**UTAH DIVISION OF RADIATION CONTROL
ENERGYSOLUTIONS CLIVE LLRW DISPOSAL FACILITY
LICENSE NO: UT2300249; RML #UT 2300249**

**CONDITION 35 COMPLIANCE REPORT; APPENDIX A:
FINAL REPORT FOR THE CLIVE DU PA MODEL**

**SAFETY EVALUATION REPORT
VOLUME 1**

April 2015

Figure B-2 — Complementary cumulative distribution of HYDRUS and GoldSim α parameters

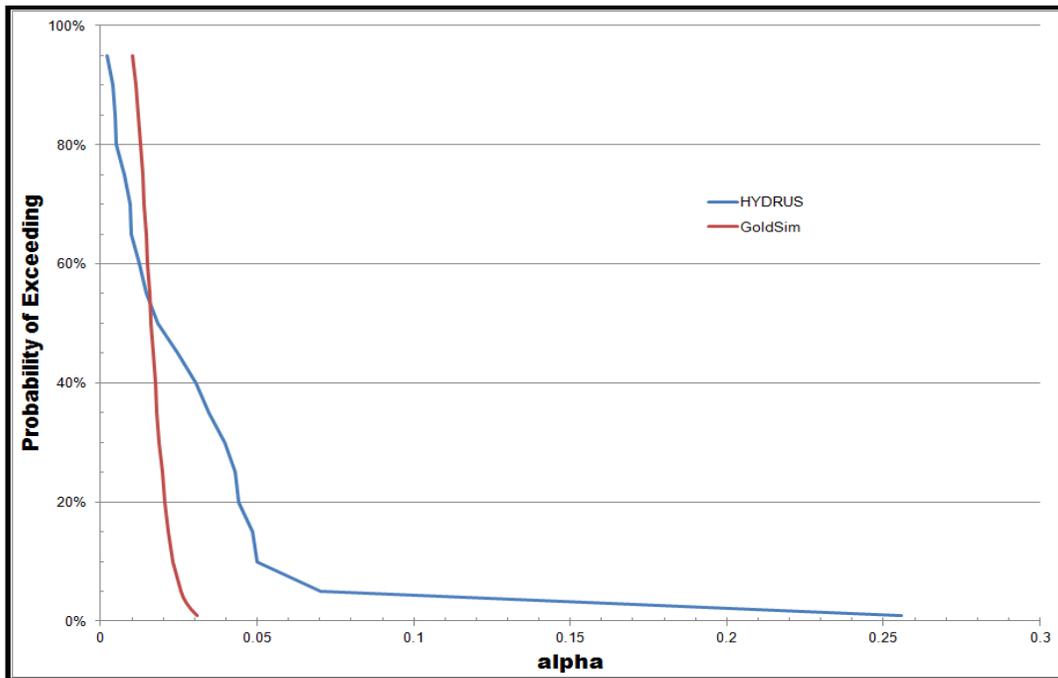
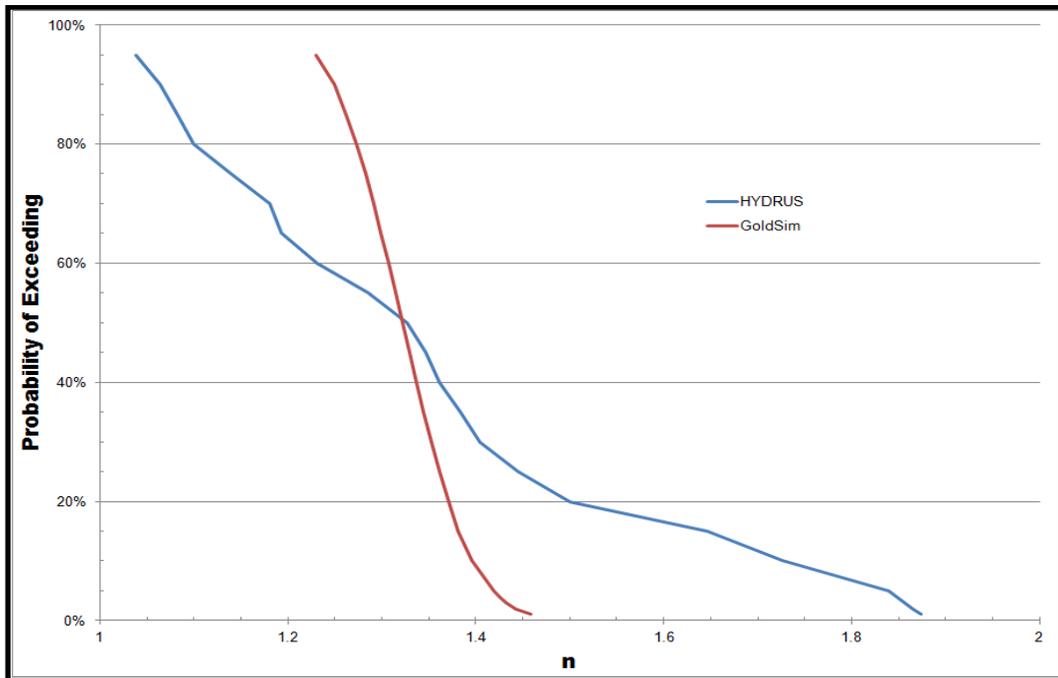
2) As acknowledged by EnergySolutions in its responses to Supplemental Interrogatories 1 and 2, due to scaling effects the ranges for α and n that have been programmed into GoldSim are more narrow than those in HYDRUS (i.e., in HYDRUS, α ranges from 0.001883 to 0.3021, but in GoldSim, α only ranges from 0.005 to 0.0493; likewise, in HYDRUS, n ranges from 1.029 to 1.883, but in GoldSim n only ranges from 1.060 to 1.540). See Figure B-2 and Figure B-3 for complementary cumulative distribution (CCD) comparisons that were prepared by SC&A utilizing EnergySolutions HYDRUS results and the Neptune (2014b), Table 1 GoldSim α and n distributions.

Figure B-4— Complementary cumulative distribution of HYDRUS and GoldSim infiltration fluxes

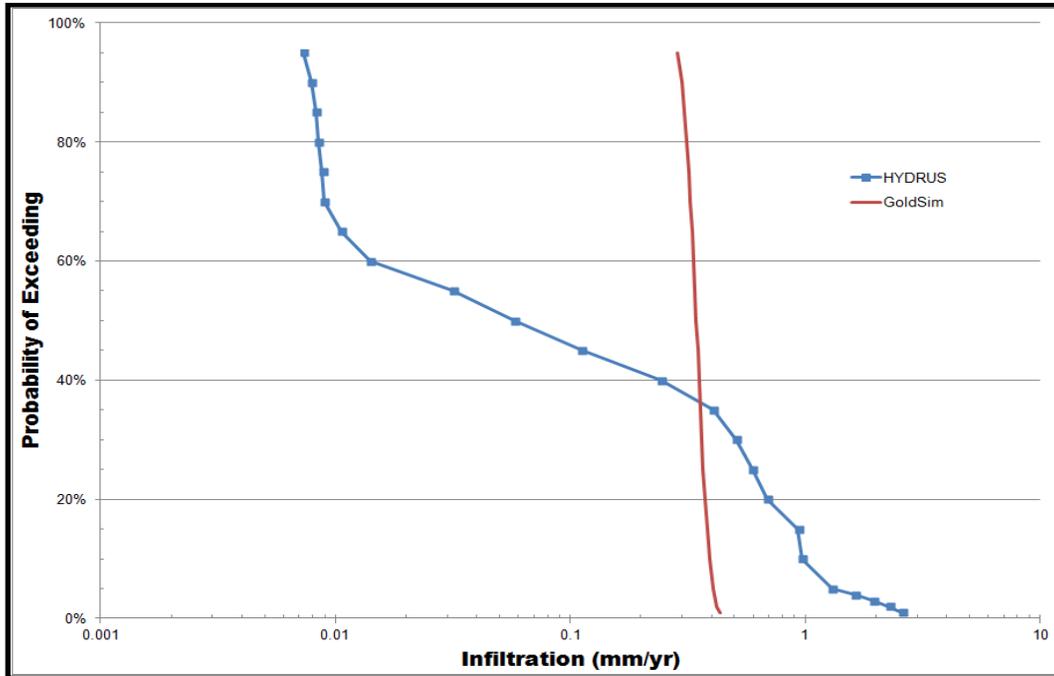
The CCD comparison in Figure B-4 shows the effect of these two mathematical considerations on the resulting GoldSim infiltration rate. This infiltration CCD is very similar to Figure 5 of the EnergySolutions Response to Supplemental Interrogatories, except that it is rotated 90 degrees.
